PZ25-12000023

City of Pompano Beach
100 W. Atlantic Boulevard
Pompano Beach, FL 33060

**Re: Plan Review – Costco PZ25-12000023
Comment-Response Letter**

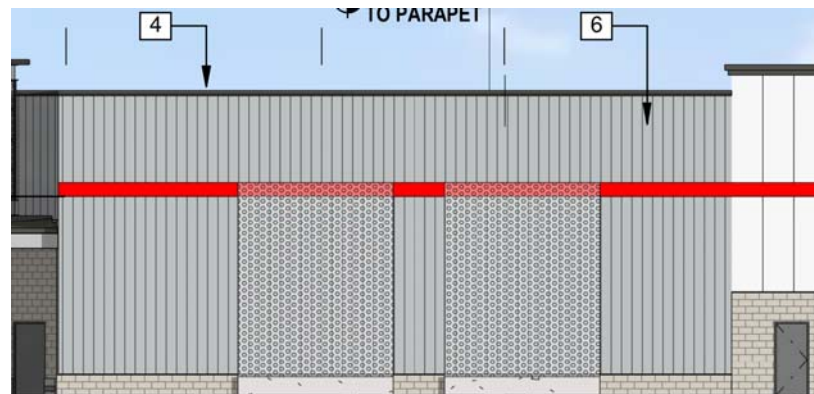
- ii. Columns or pilasters that are at least eight inches deep and at least eight inches wide, and have a height equal to at least 80 percent of the facade's height;

Response: Understood.
